Submission ID: S2076F637

Cliff Villages Solar Action Group

Comments to the Fosse Green Inspectorate Deadline Jan 20th 2026

Figure above is from NESO's [Connection Reform Results](#) Jan 2nd 2026

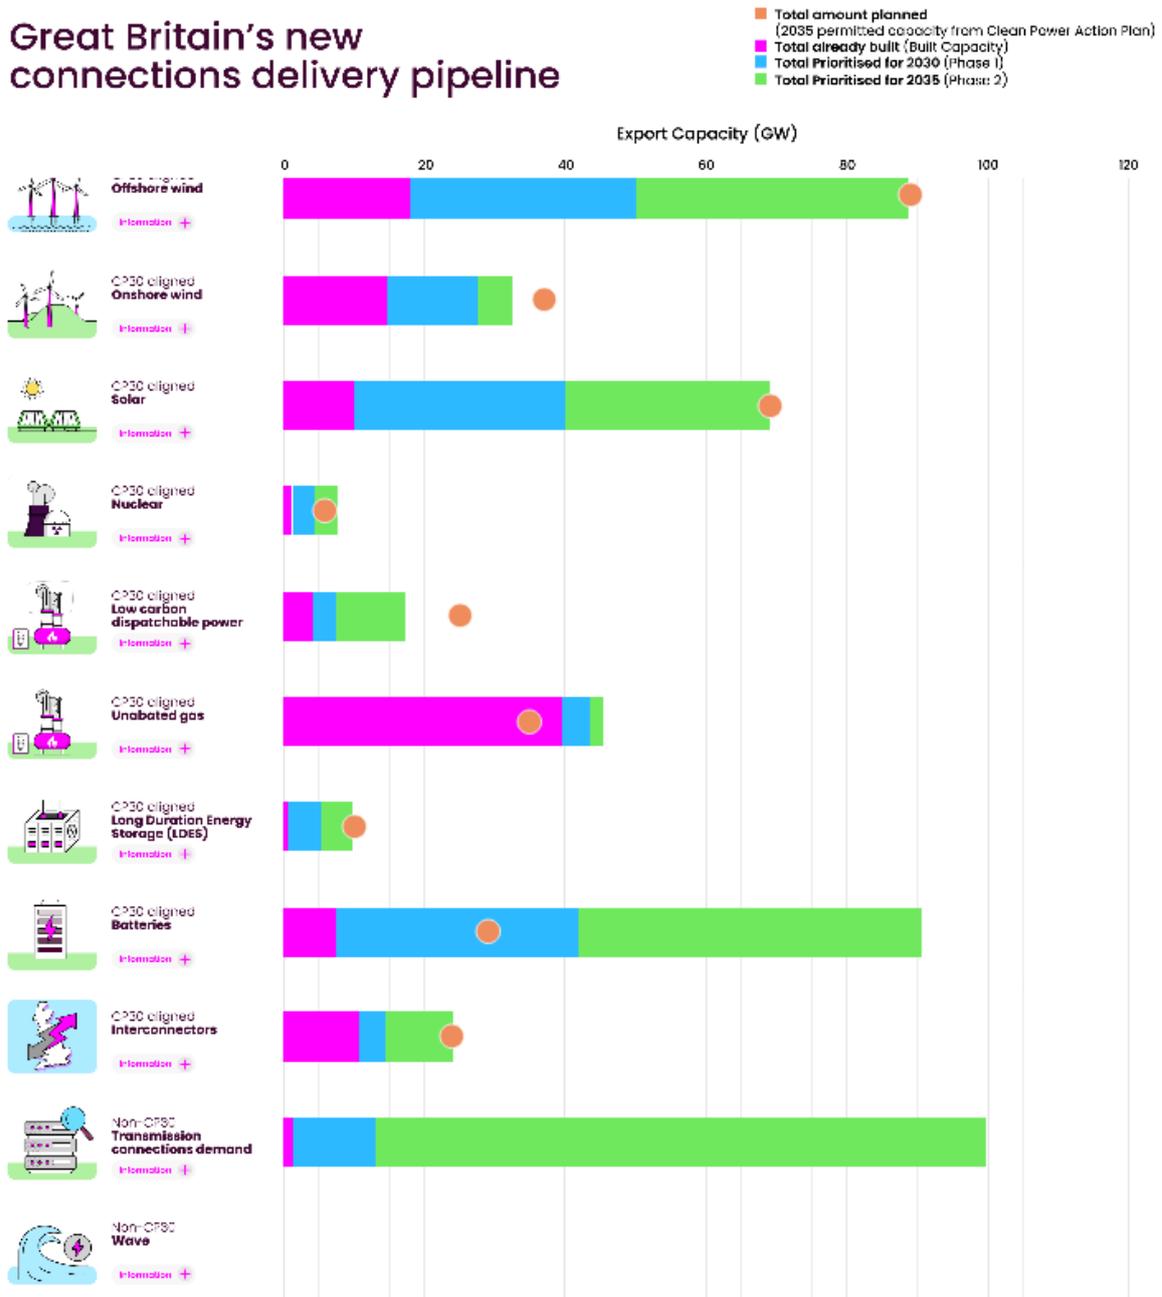
- 5.6 The NESO Connections Reform Results demonstrate the need for solar is close to requirement for 2035, but it does not include solar on roofs. I have personally asked the Minister for Net Zero how much solar is from commercial and private roofs, and this is now published on the NESO site under “*Solar photovoltaics deployed by capacity*” “*Table_1_by_capacity*” and “*Table_1_by_capacity_new*”. In November 2025 the UK cumulative Solar photovoltaic capacity was 21.481 GW, “of which domestic” is 6.273 GW, not in the NESO graph.

- 5.7 NESO’s Connections Reform Results demonstrate that the need for solar is also over capacity for 2030 and for 2035, significantly reducing the weight of benefit of this proposal. Over supply of electricity is a significant disbenefit, as “Constrain costs” were 1-5-1.8bn in 2024. **Applications that can connect to an existing, built grid capacity should be prioritised with greater weight of benefit**, and would save costs. NESO’s “control allows a more strategic approach, including regional targets, rather than allowing a few landowners to dictate planning policy.
